SERVICE CAMPAIGN BULLETIN

CAMPAIGN REF : 021

TITLE : Clash condition between low temperature radiator pipe and steering rack gaiter

DOCUMENT # : 11 L 001

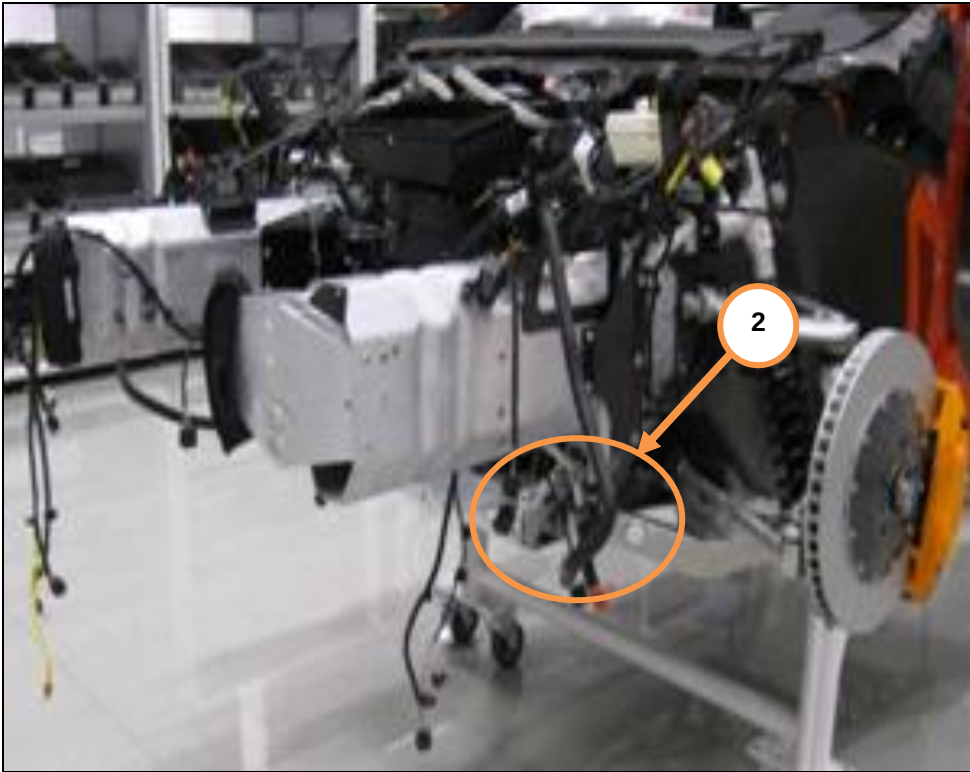
1. An example of the clash condition between the LTR pipe and steering rack gaiter is highlighted in the following image (1).

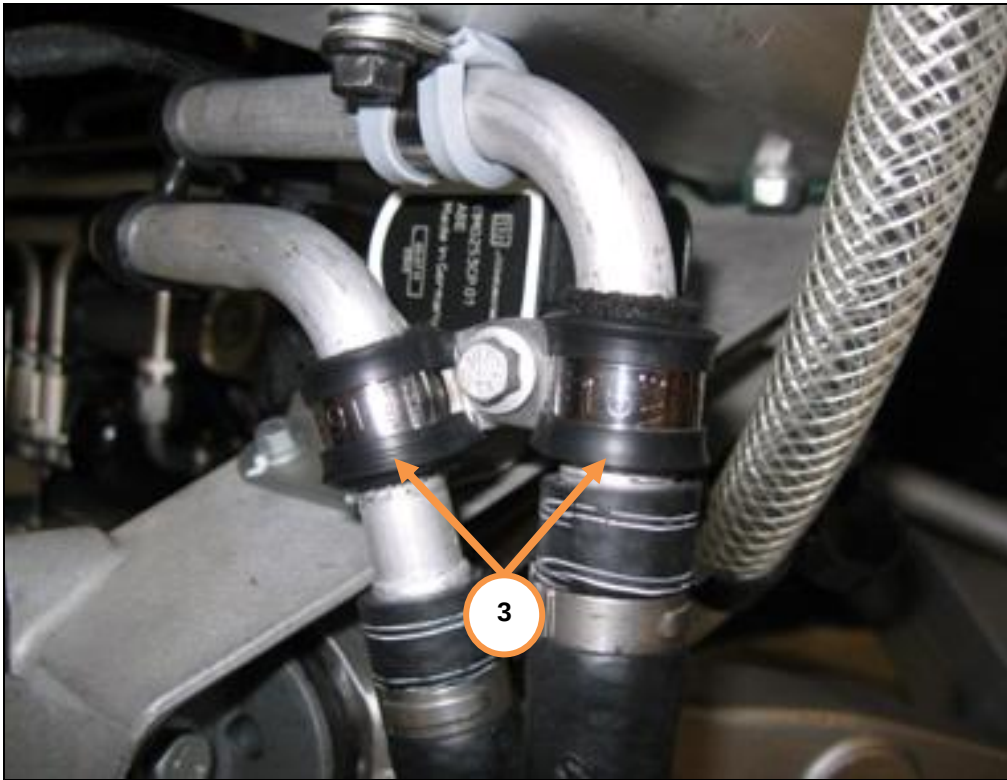
2. The following image shows the location, on the vehicle, where the rework is necessary (2).

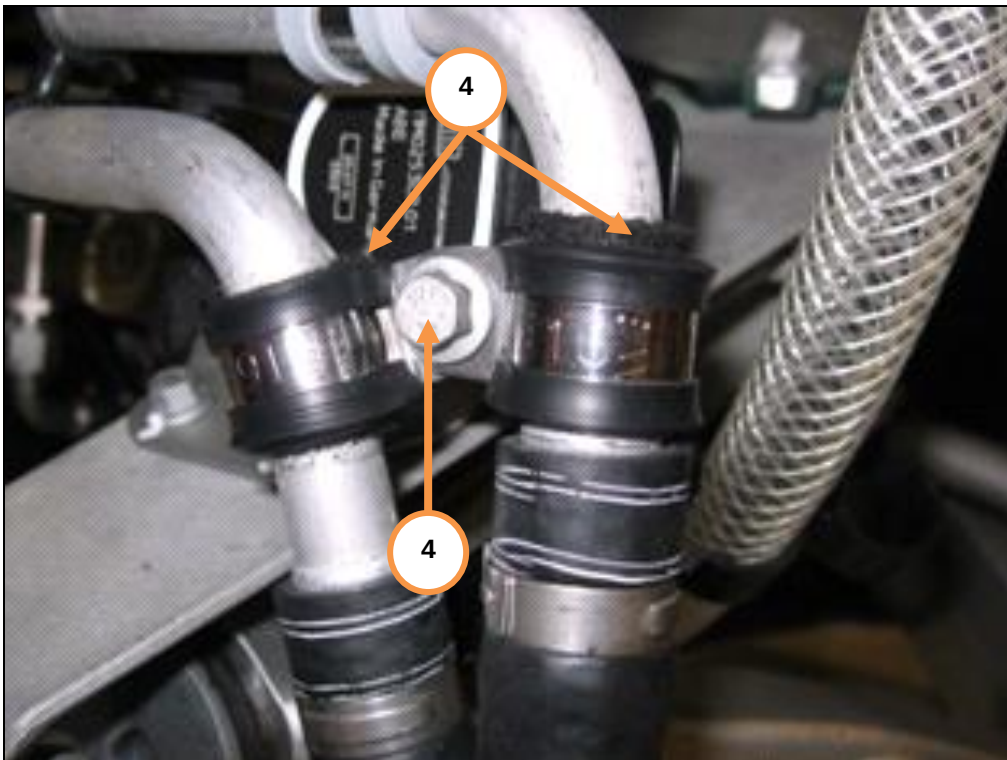
3. Please refer to AA-RM-02A04-04-007 – Lift vehicle on lifting platform
4. Please refer to AA-RM-03B03-01-001 – Remove/install wheel
5. Please refer to AA-RM-02A02-03-002 – Remove/install wheel arch liner – Front (left)
6. The two P-clips (3) shown in the following image require replacement with new variants (00RB005).

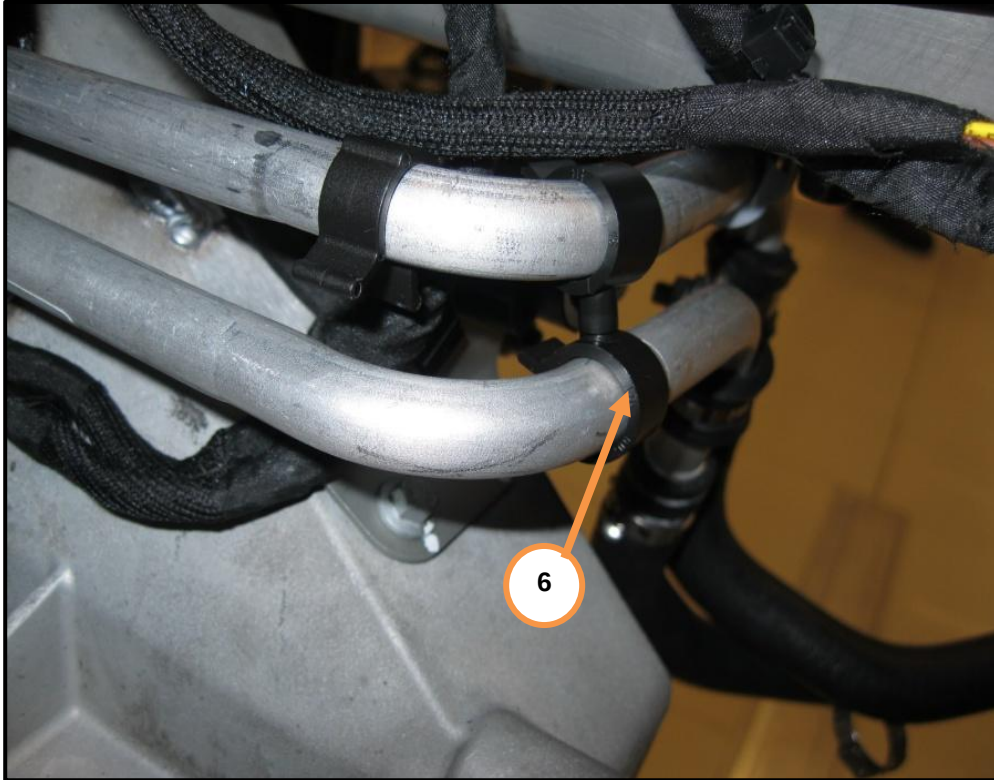
7. Apply 1 x 50mm long piece of felt tape that has been cut in half length wise. Apply each half exactly to these pipes as shown on the following image (4). This will allow the new P-Clips to sufficiently grip. Using the M6x16 Hex screw and M6 Locking nut (5). Torque to 6Nm.

Care point: The clips must be placed exactly as shown in order that the pipes are secured in place.

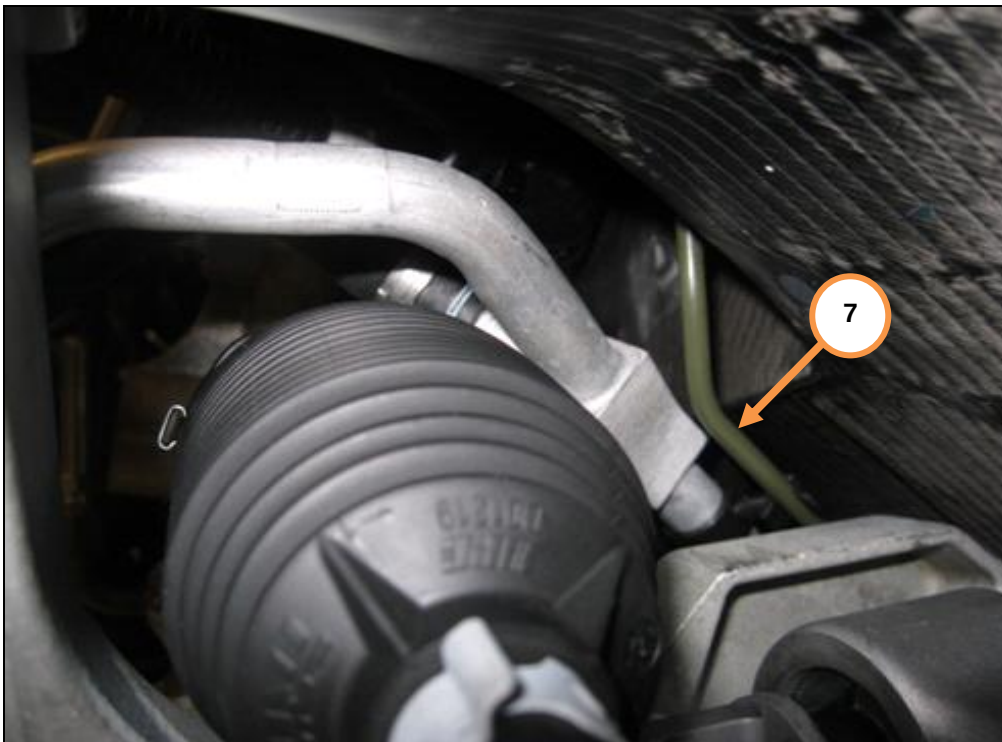
8. Apply the 16mm swivel pipe clips (00RB044) and 13-14mm female clip (00RB032) as shown (6).

9. There should now be sufficient clearance between the LTR pipe and the gator. This ensures that the LTR is more inboard in relation to the brake pipe (7).
